Groundwater Application Review Summary Form

Application # G- 18629

To: Kristopher Byrd, Well Construction and Compliance Section Manager
From: Joel Jeffery, Well Construction Program Coordinator
Subject: Review of Water Right Application G-18629
Date: August 28, 2018

TO: Water Rights Section Date 6/28/2018
 FROM: Groundwater Section Benjamin Scandella, Dennis Orłowski
 Reviewer's Name
 SUBJECT: Application G- 18629 Supersedes review of _____
 Date of Review(s) _____

D1. Well #: _____ Logid: _____

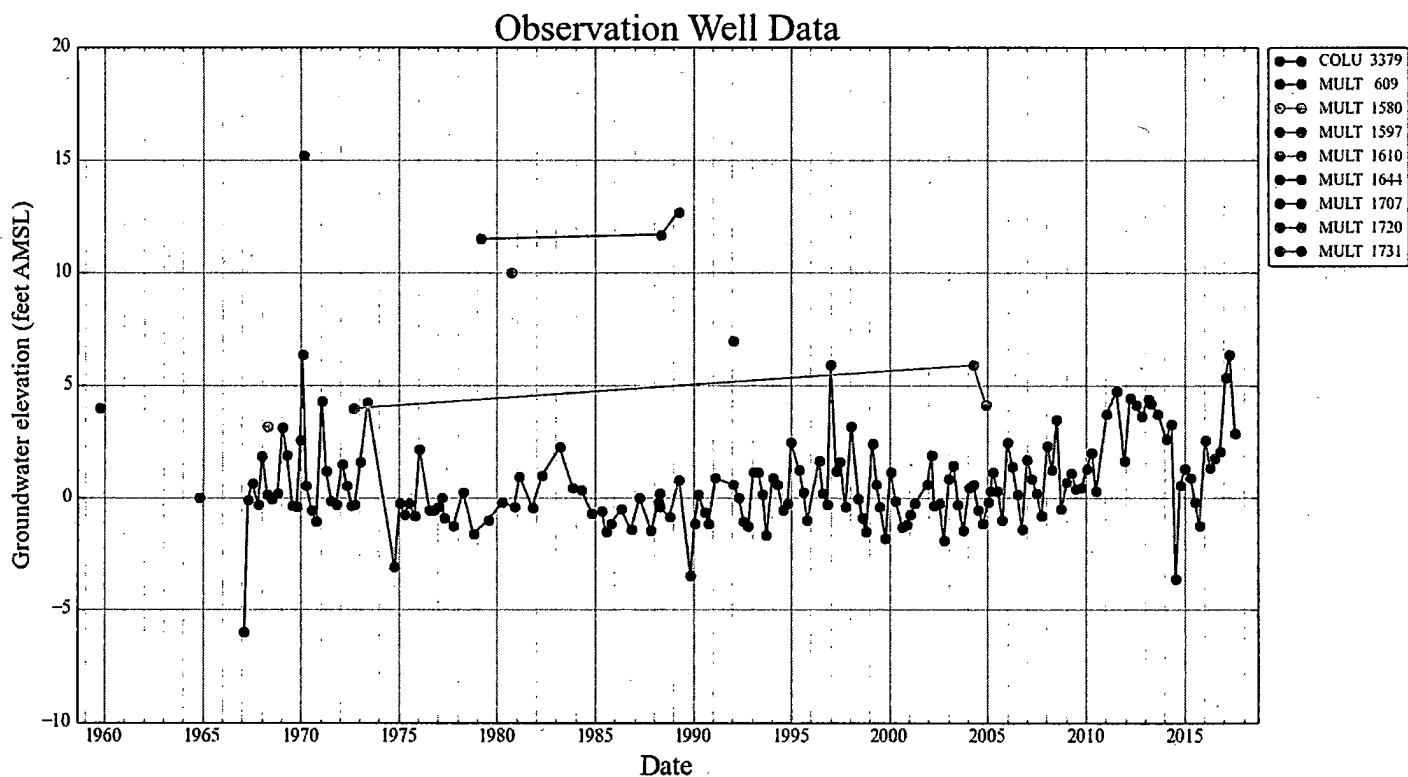
D2. THE WELL does not appear to meet current well construction standards based upon:

D3. THE WELL construction deficiency or other comment is described as follows: _____

D4. Route to the Well Construction and Compliance Section for a review of existing well construction.

G-18629: Columbia Holdings, LLC. T2N/R1W-S4

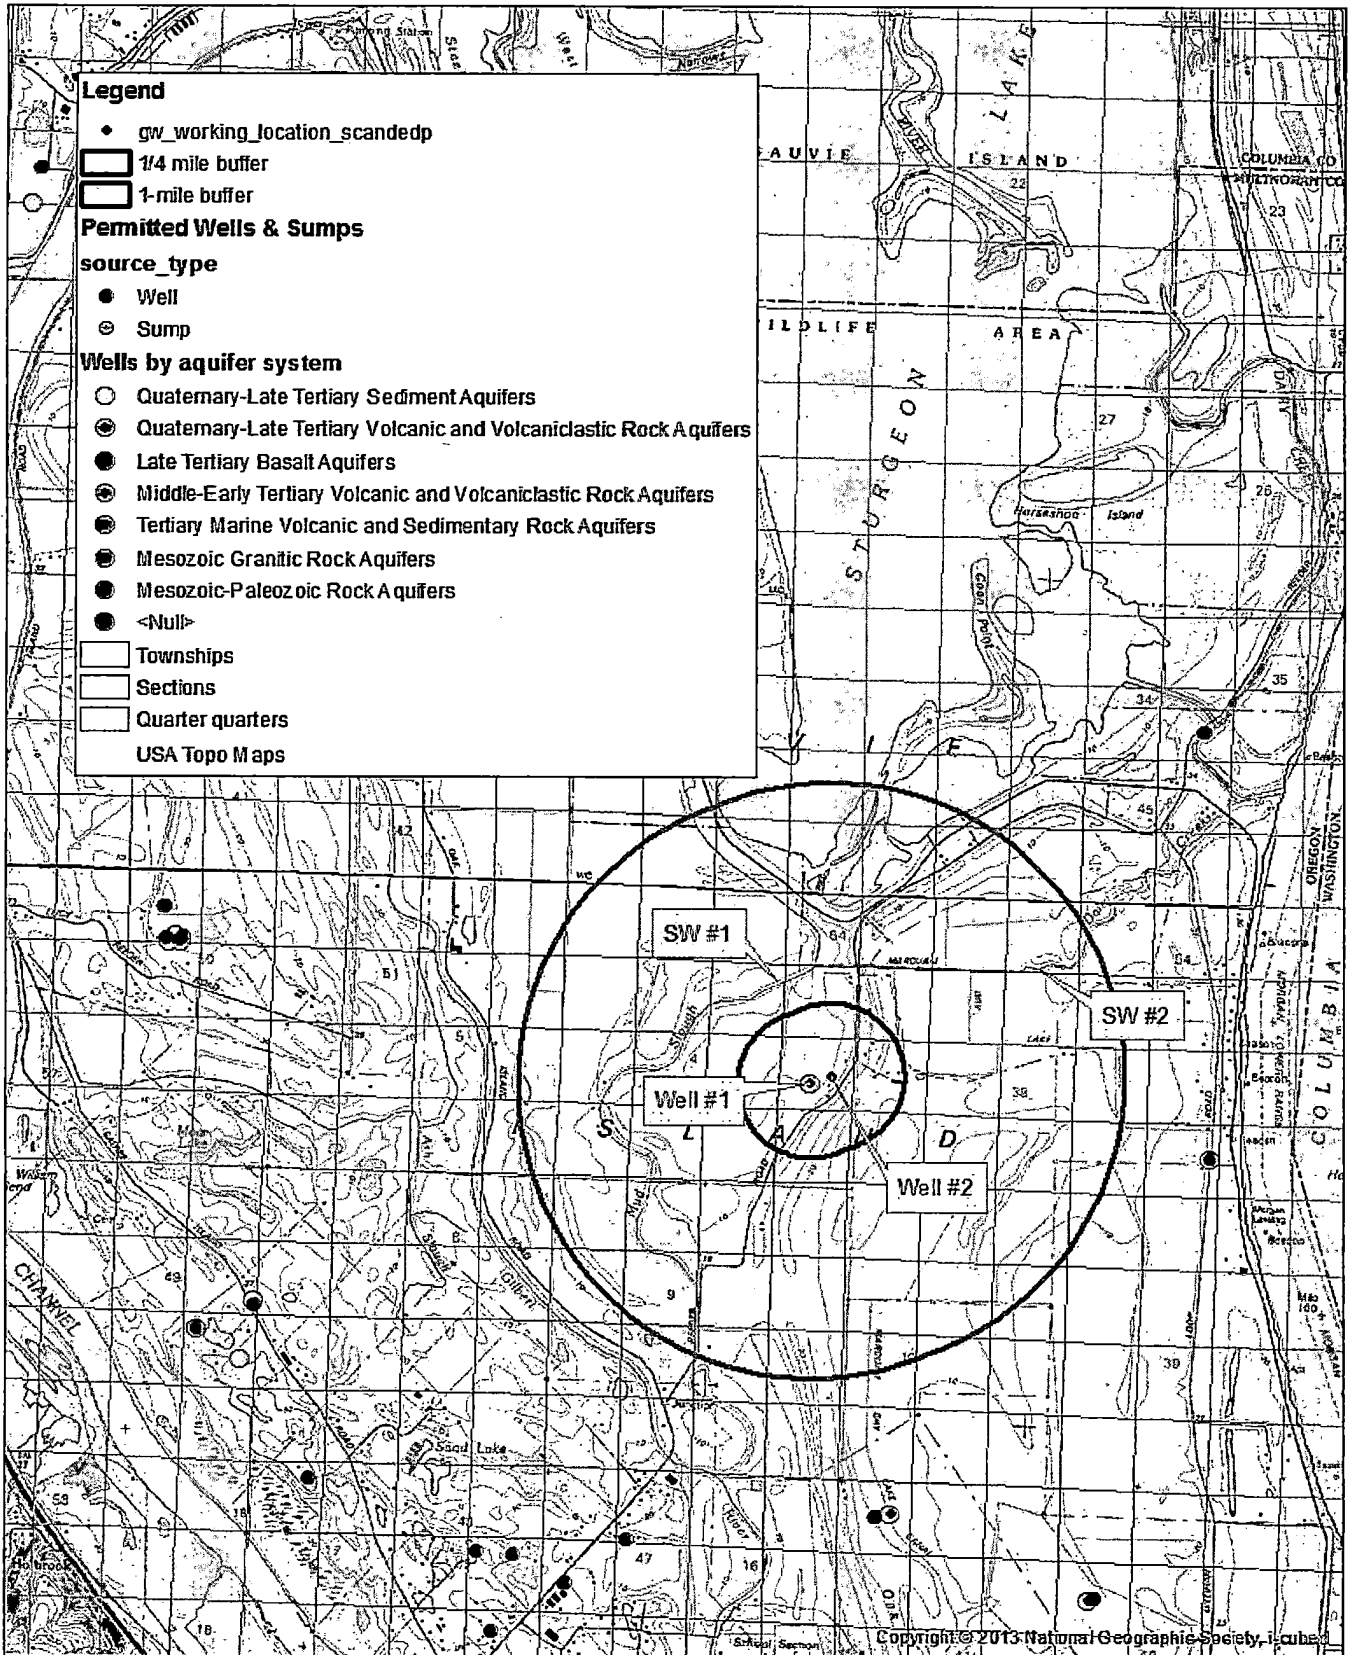
Groundwater is likely available and not over-appropriated in this area due to the large storage capacity and permeability of the aquifer materials (primarily sand and gravel) and the high rate of recharge (Conlon and others, 2005). Recharge in this unconfined USA system comes from both precipitation and nearby surface water, especially due to the proximity and efficient hydraulic connection to the Multnomah Channel. While groundwater level data for aquifer wells in the area is not available over long periods to definitively determine the current state of the groundwater resource, the nearest well showing long-term data in the sedimentary aquifer system (COLU 3379, more than 10 miles to the north) is also probably hydraulically well-connected with local surface water and shows relative long-term stability for the past 50 years. Despite this conclusion, and because local groundwater data is nearly non-existent, the permit conditions noted in B1(d)(i) are recommended to provide additional information to support future understanding and management of the groundwater resource in this area. **If the applicants provide the well log or a well inspection report for Well #2 confirming that it is open to the same aquifer system as Well #1 (pending approval from an OWRD hydrogeologist), then due to the high transmissivity of the aquifer system and the close proximity and similar completion of all the wells, it would be sufficient to provide annual water level measurements from either of the 2 wells.**

Water level trends from wells within approximately 2.5 miles of the applicant's well that obtain water from the sedimentary aquifer system, as well as the nearest sedimentary well with a long-term continuing trend (COLU 3379, over 10 miles north).
